Addendum No. 1

RE: Contract # C205234

Rockingham County

TYPE OF WORK MILLING, RESURFACING, AND SHOULDER RECONSTRUCTION.

Map 3 US 158 (Freeway Dr) (WB)*
Map 4 US 158 (Freeway Dr) (EB)*

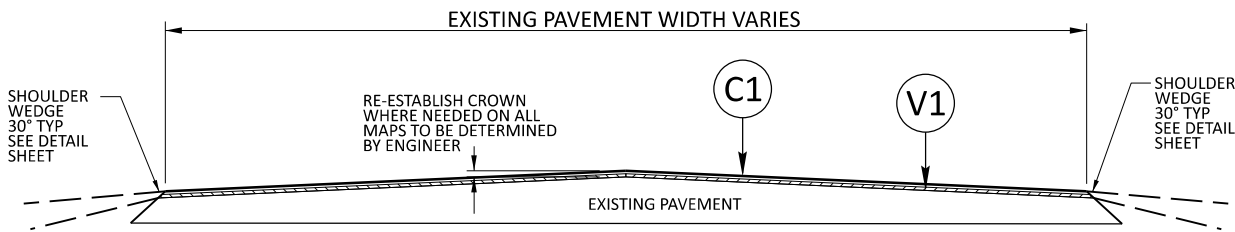
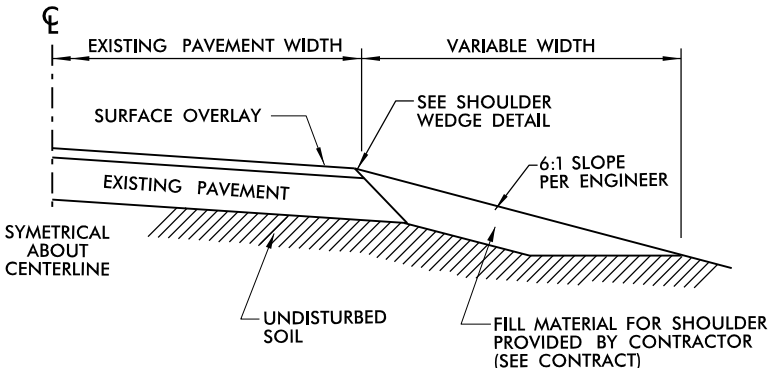
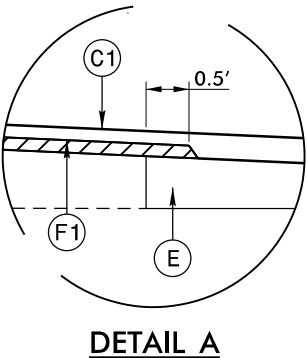
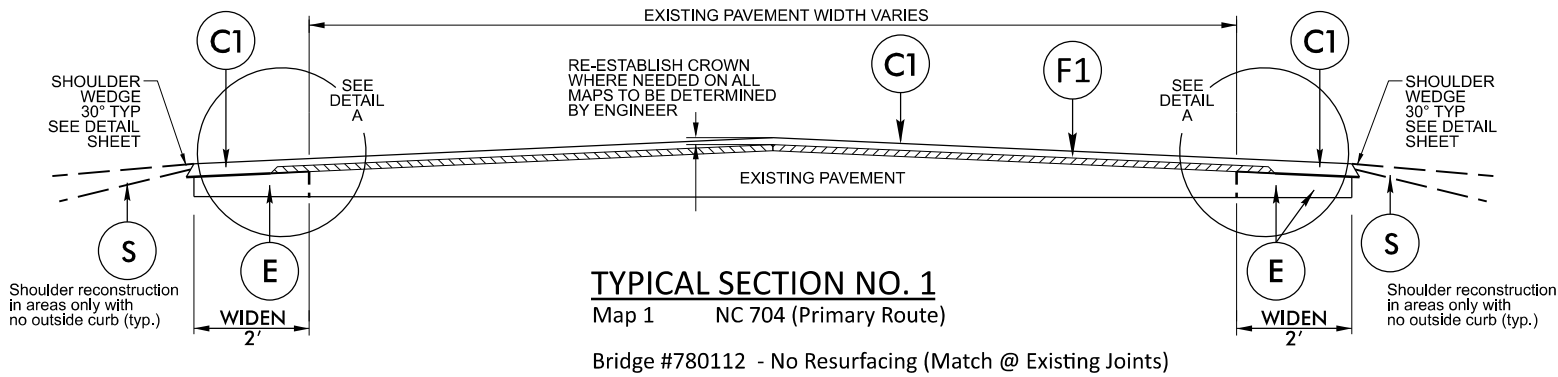
Sheet No.	Revision
5	Ramps & loops are now shown with dark lines as part of the work.
11	Typical 1 V1 1.5" milling removed and changed to F1 AST Mat Coat #78
15	SOQ updated with revised quantities below.
